Technical Review of Water-Resources Investigations of the Tule Desert, Lincoln County, southern Nevada

By David L. Berger, Keith J. Halford, Wayne R. Belcher, and Michael S. Lico

Open-File Report 2008–1354

Figure 2. Average annual precipitation for 1930–2007, 1971–2000, and 1981–2003 and the amount of precipitation exceeding 7 inches (1930–2007) for zone 3 of Nevada.

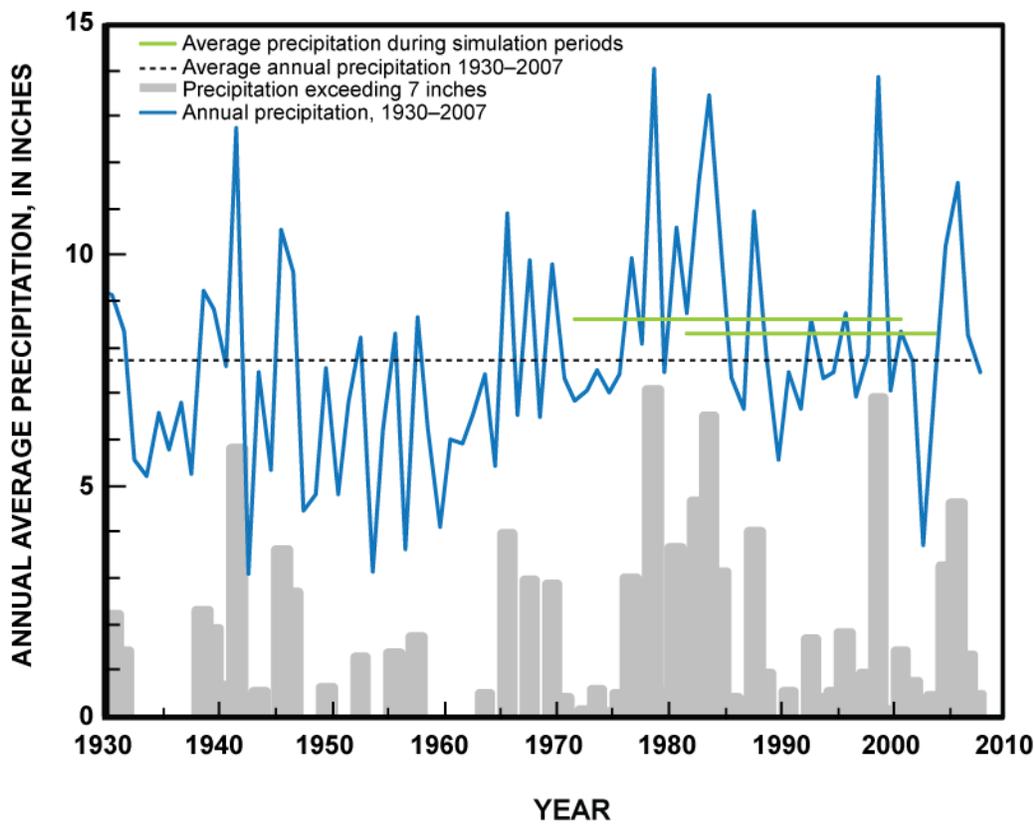
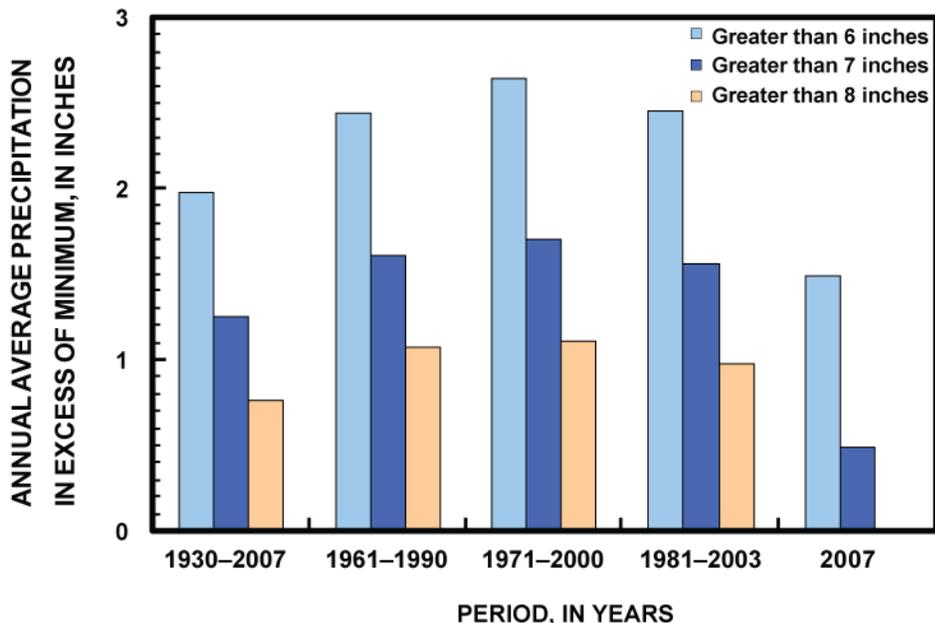
The effects of using precipitation distributions other than Hardman (1936) with Maxey-Eakin coefficients (Maxey and Eakin, 1949) was investigated by comparing precipitation volumes from Hardman (1936, 1965) and PRISM (1971–2000; Daly and others, 1994) in the hydrographic areas (HA) where the Maxey-Eakin technique was originally developed. Ground-water recharge estimates for a HA should represent long-term or steady-state conditions. Steady-state conditions did not exist during the periods (1971–2000 and 1981–2003) that were simulated with the water-balance model (report 3, table 8-1). Average annual precipitation for zone 3 of Nevada (NV03) during the simulated periods often exceeded the long-term average annual precipitation between 1930 and 2007 (fig. 2). Average annual precipitation for NV03 ranged between 8.63 and 8.33 in. during the two simulated periods, although the average for the entire 78-year period (1930–2007) was 7.72 in. This suggests that recharge during the simulated periods are biased above long-term recharge rates.

The difference between simulated periods and the 78-year record are greater when precipitation in excess of a minimum (PEM) is compared (fig. 2). A PEM roughly simulates a threshold of annual precipitation where ground-water recharge from precipitation does not occur. PEM values of 6, 7, and 8 in. were applied to four time periods, including the simulation periods of 1971–2000 and 1981–2003 and water year 2007 (fig. 3). A 6-in. PEM approximates the ratio between recharge estimates derived

from National Climatic Data Center (NCDC) 1971–2000 annual average precipitation and total precipitation for water year 2007. An 8-in. PEM approximates the Maxey-Eakin threshold. Long-term ground-water recharge will be less than recharge during 1961–90, 1971–2000, and 1981–2003 for any PEM between 6 and 8 in.

Average long-term recharge can be estimated from the simulated periods by relating annual recharge from the water-balance models to a threshold-limited power function. Annual recharge during the 78-year record can be extrapolated with this simple function after fitting to recharge estimates during the simulated periods: 1961–90, 1971–2000, or 1981–2003. This approach was applied previously in the BARCAS study (Welch and others, 2007) to estimate long-term recharge from a basin characterization model (Flint and Flint, 2007). Neglecting antecedent conditions from previous years introduced error, but minimally affected estimates of the average long-term recharge. Long-term recharge averaged 9 percent less than the recharge simulated during 1970–2004 (Flint and Flint, 2007).

Figure 4. Comparison of areas in selected precipitation zones of Hardman 1936 and 1965 precipitation distribution within 19 hydrographic areas originally used in the development of the Maxey-Eakin method for estimating ground-water recharge from precipitation.

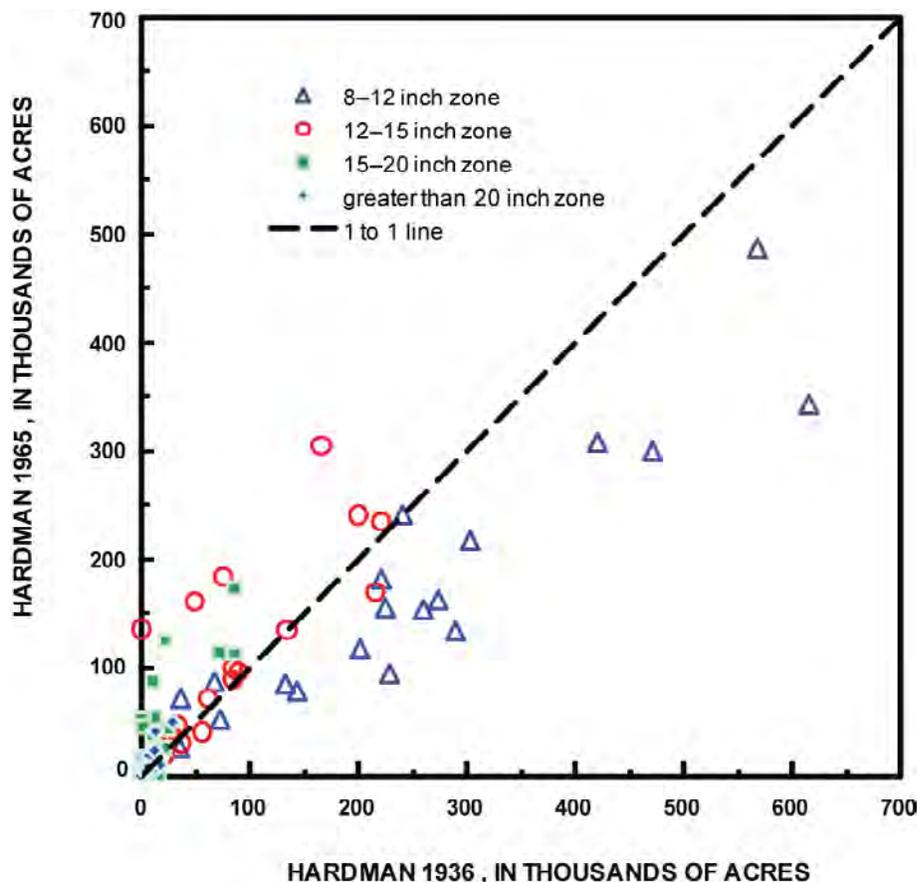
Precipitation volumes in the 19 HAs used for the original Maxey-Eakin analysis were compared to test the effect of precipitation distributions on recharge estimates. However, some uncertainty persists regarding the measured volumes of ground-water discharge in these 19 HAs because Maxey and Eakin (1949) did not provide significant detail in their analysis. Additionally, ground-water discharge from a few of the 19 HAs that were used to develop the Maxey-Eakin coefficients may be poor controls. For example, ground water in Kawich Valley (HA 157) does not discharge within this HA. The 19 HAs can still serve as controls for comparing precipitation distributions even if the Maxey-Eakin coefficients were developed with a few less HAs.

The Hardman 1936 and 1965 precipitation distributions cannot be used interchangeably with the Maxey-Eakin coefficients primarily because the acreages in the discrete ranges of 8–12, 12–15, 15–20, and greater than 20 in. are quite different between the two precipitation distributions (fig. 4) even though the gross acreage in excess of 8 in. is comparable between the two precipitation distributions (report 4, fig. 21). Acreage in the 8–12 in. range on the 1965 map was less than the same range on the 1936 map, although acreage increased in the 12–15, 15–20, and greater than 20 in. ranges resulting in a ground-water recharge estimate that averaged 38 percent greater using the Hardman 1965 rather than the Hardman 1936 map when applied to the 19 HAs (fig. 5).

Figure 5. Comparison between ground-water recharge estimates using Hardman 1965 precipitation distribution with the original Maxey-Eakin coefficients and the Hardman 1965 precipitation distribution with second set of coefficients that preserves the original recharge estimates.

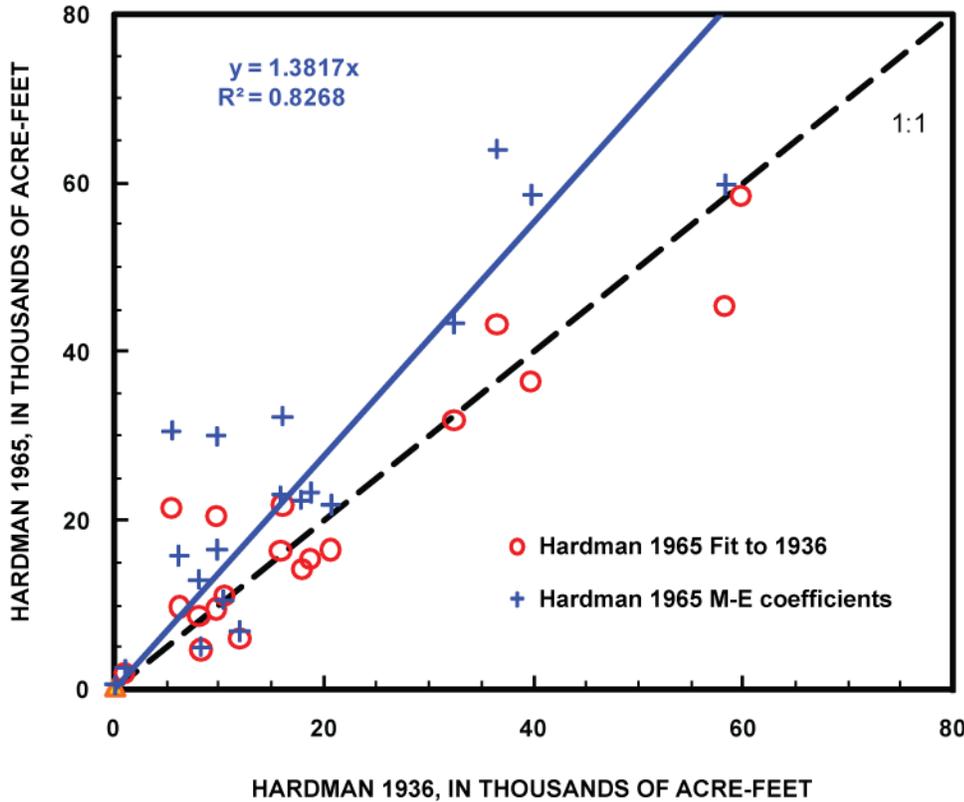
Total ground-water recharge is 570,000 acre-ft using the 1965 precipitation distribution, which is 47 percent more than 388,000 acre-ft using the 1936 precipitation distribution. Annual recharge estimates for the Tule Desert increased fivefold if Hardman 1965 is used instead of Hardman 1936, but remained less than 1,000 acre-ft. Existing errors in the attributes of the USGS digitized Hardman 1936 precipitation distribution were corrected and the revised map was used for this review. The corrections primarily affected areas along the eastern boundary of Nevada and particularly affected precipitation estimates in the Tule Desert.

Figure 6. Relation between precipitation and recharge efficiency for Maxey-Eakin and Wilson-Guan methods and a power function for precipitation minus 8 inches.

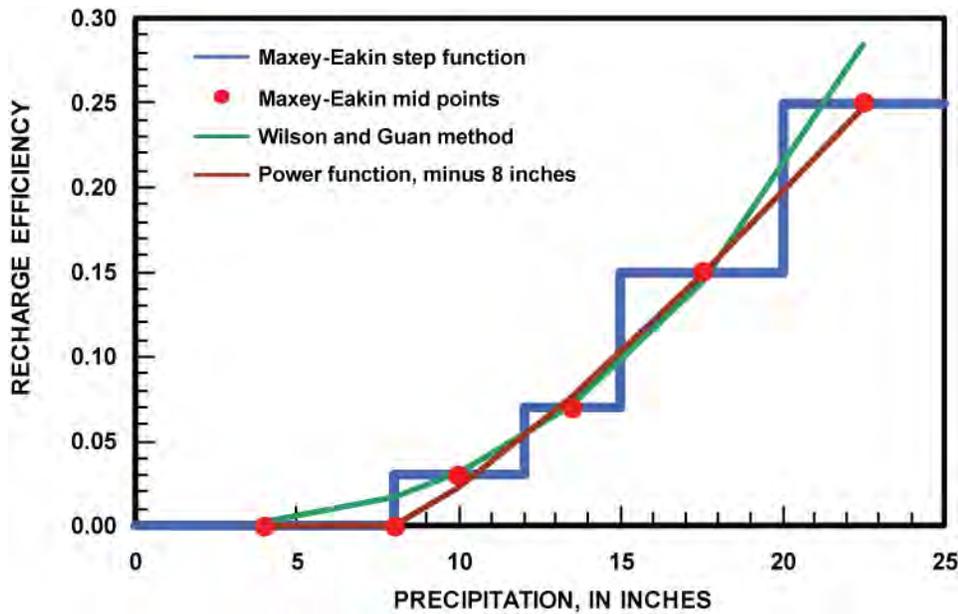
Wilson and Guan should be reported but not used. Equation 3-3, $R = 9 \times 10^{-9} Pm^{3.72}$, demonstrated that Maxey-Eakin approximated a power-law relation (Wilson and Guan, 2004). Wilson and Guan (2004) did not apply equation 3-3 and did not discuss that Maxey-Eakin coefficients are tied to the Hardman 1936 precipitation map. Equation 3-3 does not approximate Maxey-Eakin where precipitation is less than 8 in., which is more than 90 percent of the Tule Desert on the Hardman 1936 map. Large differences exist because recharge occurs where annual precipitation on the Hardman 1936 map exceeds 4 in. rather than 8 in. (fig. 6).
